**Corrective Action Plan for  
Expanded Bioventing System**

**Site SS-41**

**Former Building 93 (Fuel Pumping Station No. 3)**

**APPENDIX B**  
**REGULATORY COMMENTS AND**  
**RESPONSE TO COMMENTS**

Figure 4.1

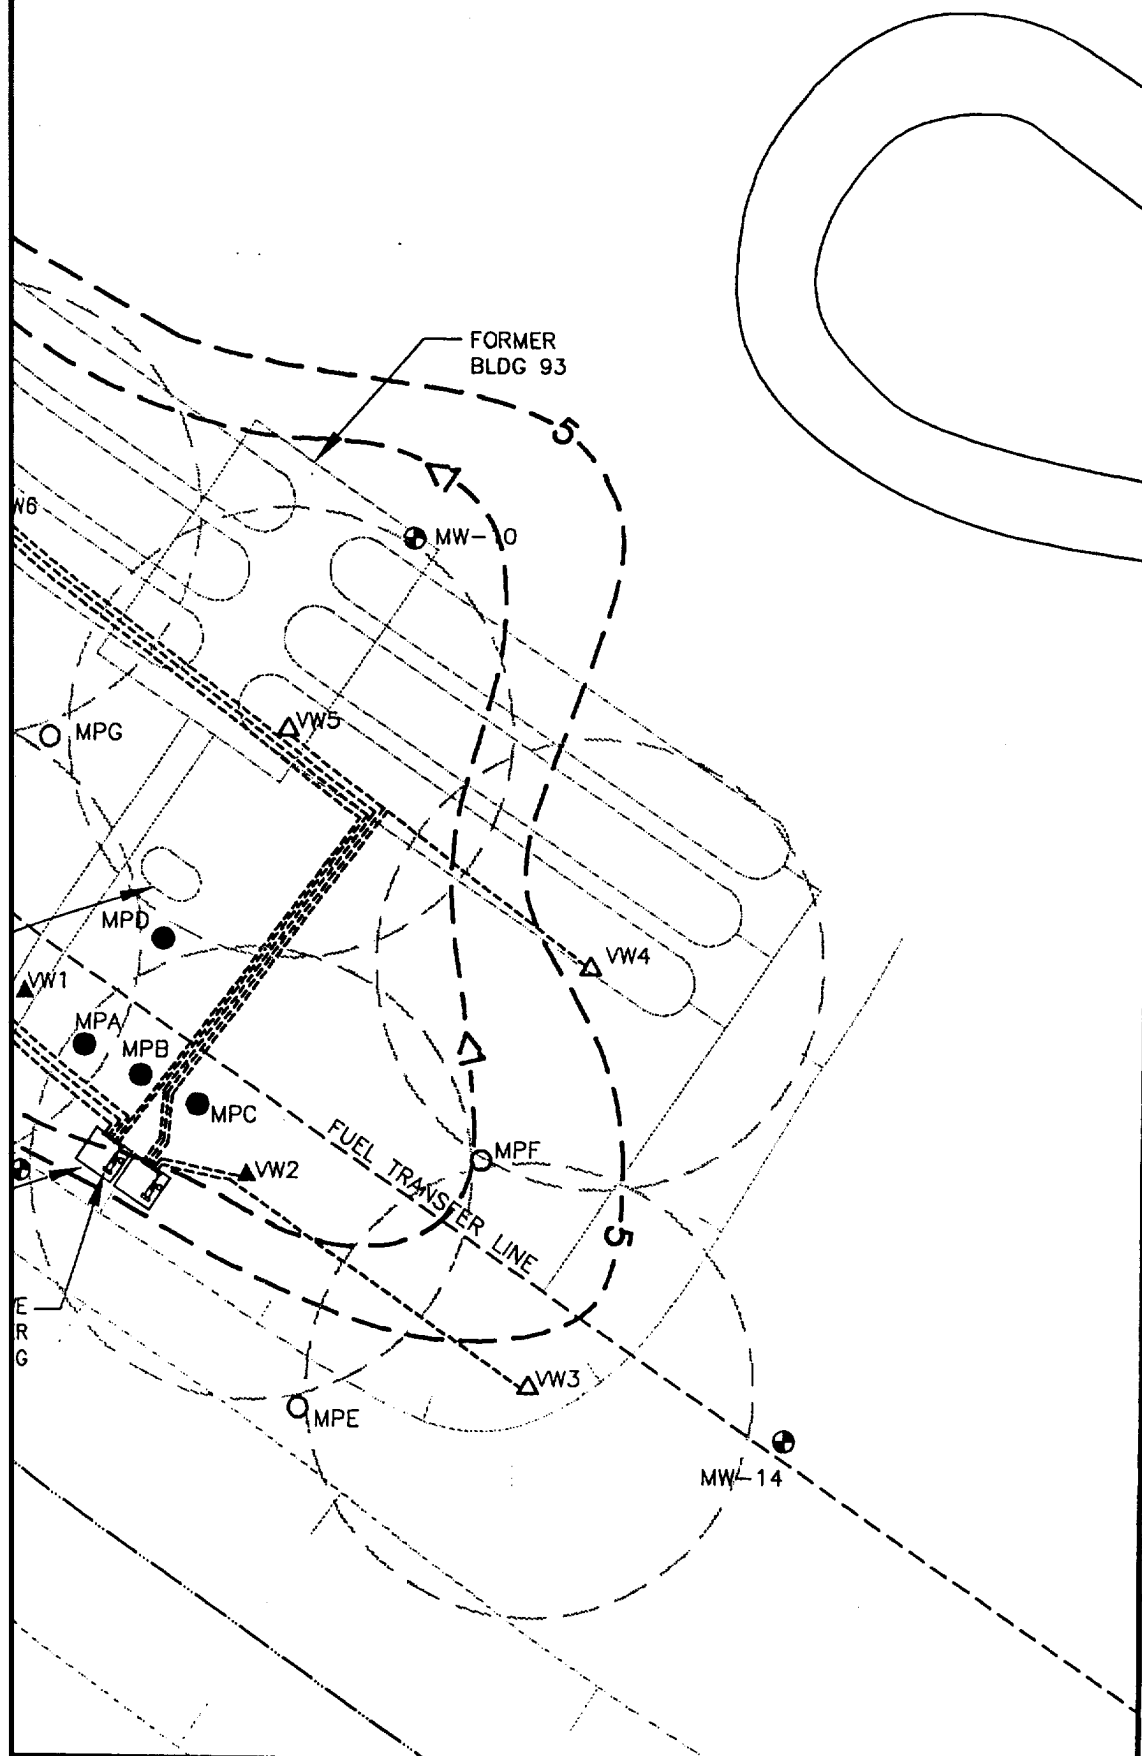
**Comment:**

Please refer to Figure 4.1 on page 4-4. Also, see the sketch that is provided as part of this attachment. Groundwater monitoring wells MW-10, MW-11, MW-12 and MW-14 are proposed for groundwater analysis.
